DESCRIPTION: **Combined Modification Document -  
Modification Note 49  
TCTO 31P1-4-108-563  
EEM 6345.1 Change 24, Chapter 21  
Installation of a Gasket and Teflon  
Tape to the Blower Assembly in the  
Transmitter Cabinet**

# **INSTALLATION OF A GASKET AND TEFLON TAPE TO THE BLOWER ASSEMBLY IN THE TRANSMITTER CABINET**

## **DOPPLER METEOROLOGICAL RADAR WSR-88D**

**Data Code: 3118335**  
**Issuance Number: EHB 6-00-11**  
**Issuance Date: 29 November 2000**  
**DoD/NWS Rescission Date: 1 December 2001**

Figure 2. Teflon Tape Over Plenum Opening

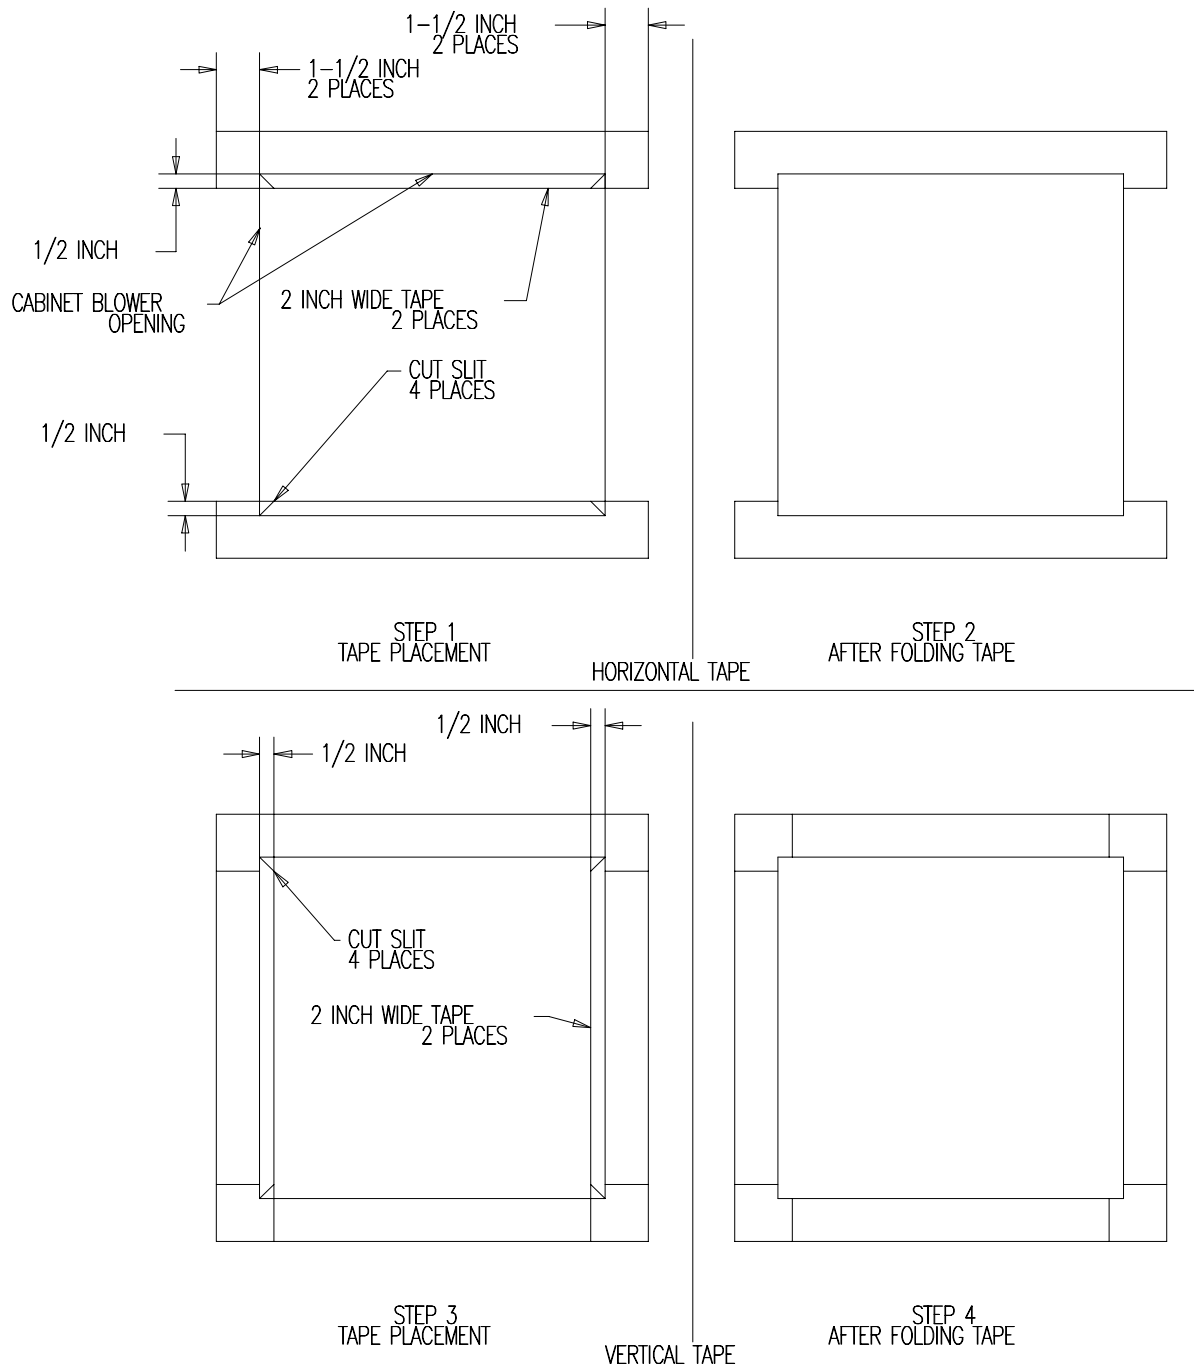
- b. Using the Teflon tape and the Exacto knife provided in the kit, cut (4) four pieces 14 inches long.
  - c. Apply one piece of 14-inch Teflon tape to each vertical and horizontal edge of the blower plenum opening. The tape should extend approximately 1/2-inch over the sharp edge of the opening.

- d. Using the Exacto knife, slit the tape at the corners of the plenum opening, and fold the tape over the sharp edges of the opening (see [figure 2](#)). It may be necessary to trim the Teflon tape to maneuver around the center plenum opening support.

Figure 3. Re-identification Label Locations

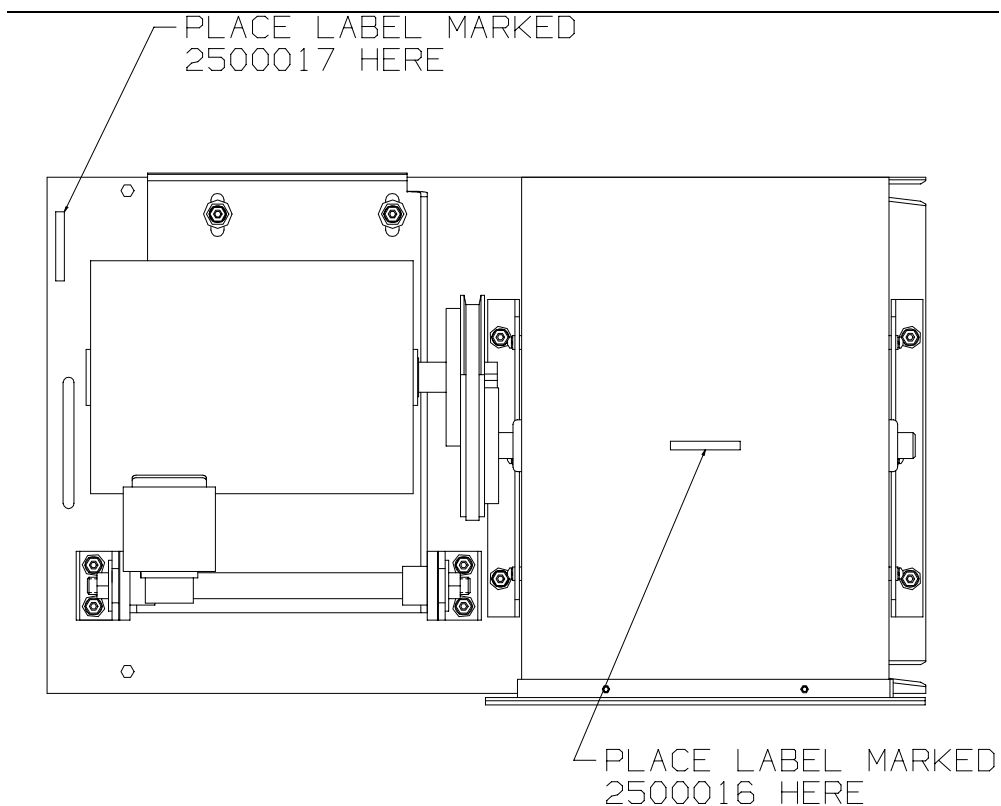
4. Perform the following steps to install the new bracket assembly along with gaskets:
  - a. Using a proper holding screwdriver, remove the (2) two-piece frame sealing the blower housing assembly to the cabinet.
  - b. Attach the new bracket and gasket assembly, using the screws removed in the previous step, to the blower housing assembly.
  - c. Perform the belt tension adjustment Preventive Maintenance Instruction (PMI) 2-031, in EHB 6-503-2 (AF TO 31P1-4-108-6WC-2, FAA TI 6345.1 V4), if necessary.
  - d. Using the labels provided in the kit re-identify the blower assembly and the blower (see figure 3).
